Re: Application No. AC 21892

ANHEUSER-BUSCH COMPANIES, INC.
JACKSONVILLE BREWERY
GRAIN DRYER NO. 1
APPLICATION NO. 21892
FOR SOURCE MODIFICATION
RESPONSES TO TECHNICAL DISCREPANCIES

Completeness Report for Modification to Anheuser-
Busch Grain Dryer No. 1, Jacksonville.

Jacksonville Brewery, Rev 1 1-9-80

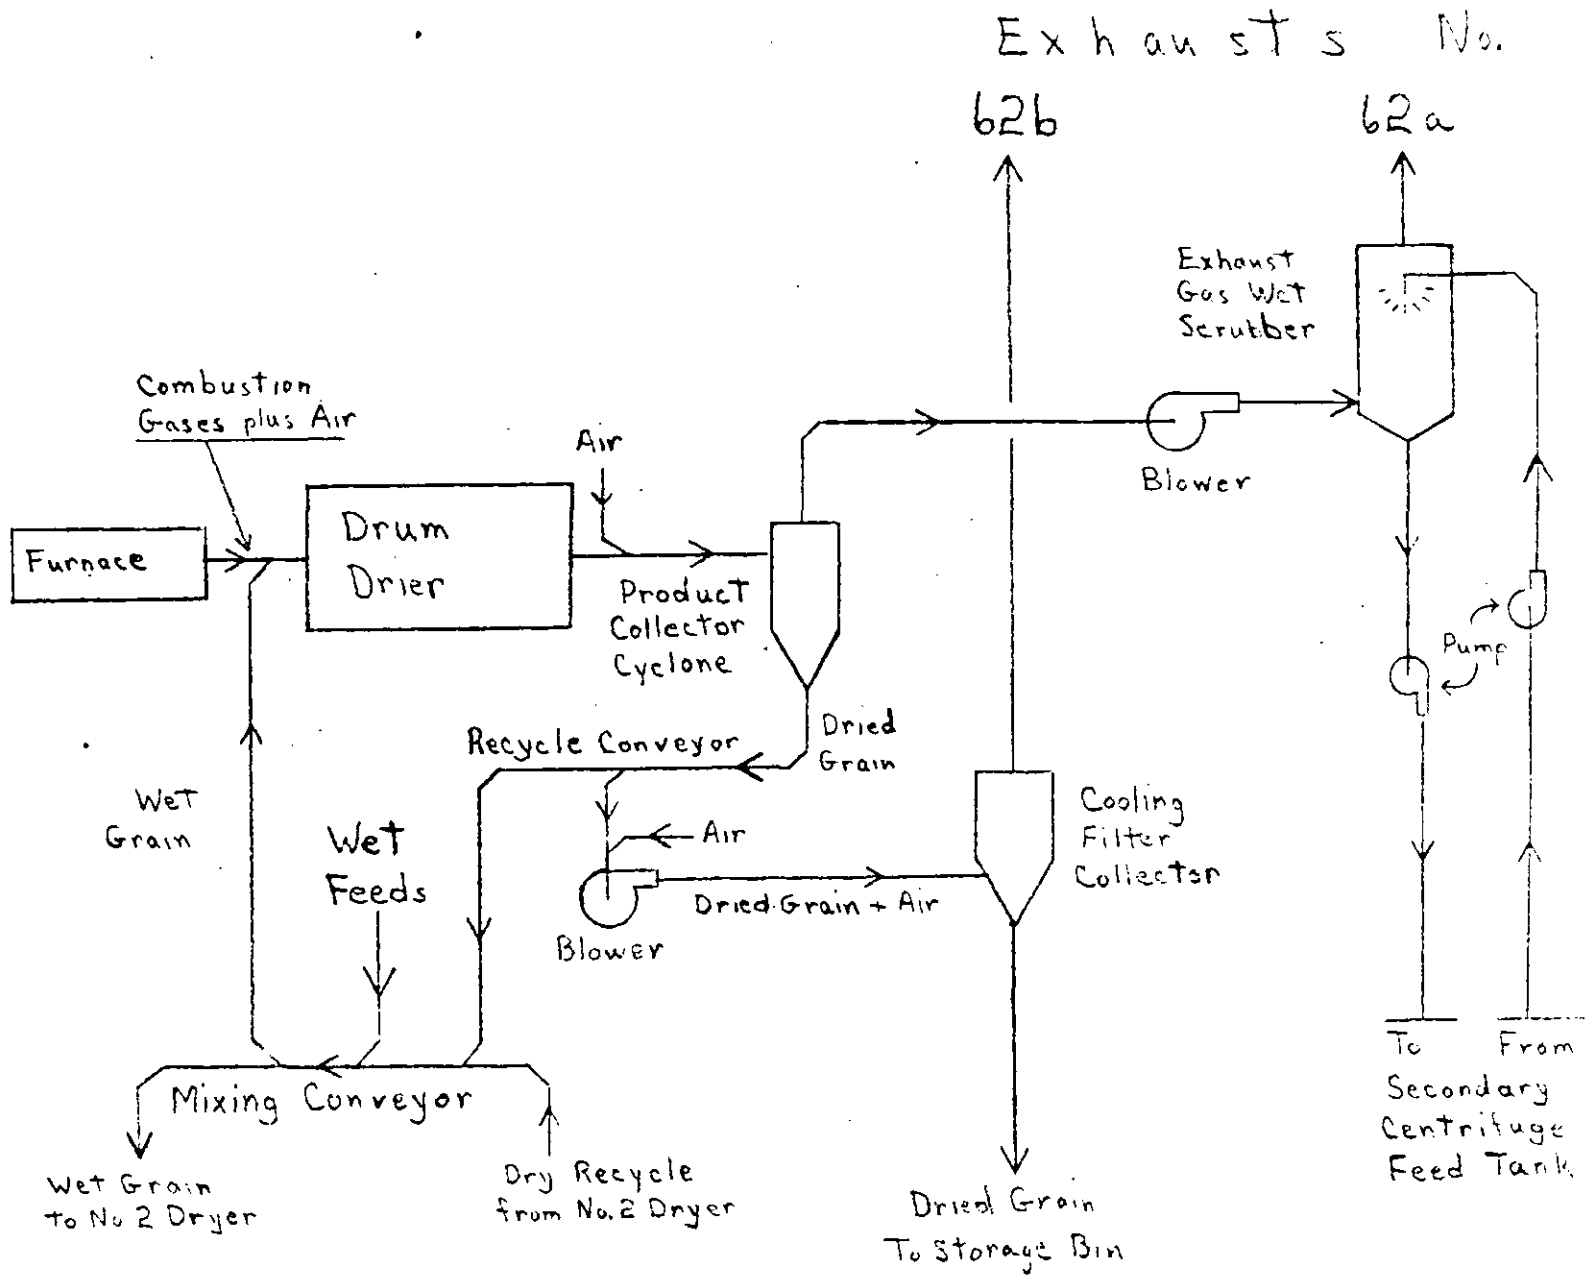
4. Continuous operating time is requested. The dryer will probably operate about 80% of the time but the exact hours in any given day, week, or month are not certain.
5. The Drawing No. 1 used in connection with the existing permit has three errors. First, the Cooling Filter Collector is mislabeled. That actually is the Cooling Collector Cyclone. Second, there is no fan between the cyclones and the scrubber. The only two conveying air fans are in front of their respective cyclones. The last error was showing the scrubber liquid as being recirculated rather than coming from the secondary Centrifuge Feed Tank. A revised drawing is included as is a revised Drawing No. 1 M for the proposed modifications.

1. Explain nature and extent of changes to dryer burner and expected change in emissions. What control exists on furnace particulate? ie Do gases pass through drum dryer or does furnace have separate stack?
2. Quantify potential emissions both in present configuration and after the proposed modifications with technical justification of emissions factors assumed to derive control device input loadings.

2. The proposed modifications will not increase the drying capacity nor the potential emissions of the dryer system. Presently the potential emissions come from the Product Collector Cyclone with about 32,000 SCFM of conveying air plus the Cooling Collector Cyclone with about 7,000 SCFM. The dust-laden air from both cyclones passes through the wet scrubber. See the enclosed revised Drawing No. 1 for the correct present configuration. A revised Drawing No. 1 M showing the modified configuration is also enclosed.

4. Continuous operating time is requested. The dryer will probably operate about 80% of the time but the exact hours in any given day, week, or month are not certain.
5. The Drawing No. 1 used in connection with the existing permit has three errors. First, the Cooling Filter Collector is mislabeled. That actually is the Cooling Collector Cyclone. Second, there is no fan between the cyclones and the scrubber. The only two conveying air fans are in front of their respective cyclones. The last error was showing the scrubber liquid as being recirculated rather than coming from the secondary Centrifuge Feed Tank. A revised drawing is included as is a revised Drawing No. 1 M for the proposed modifications.
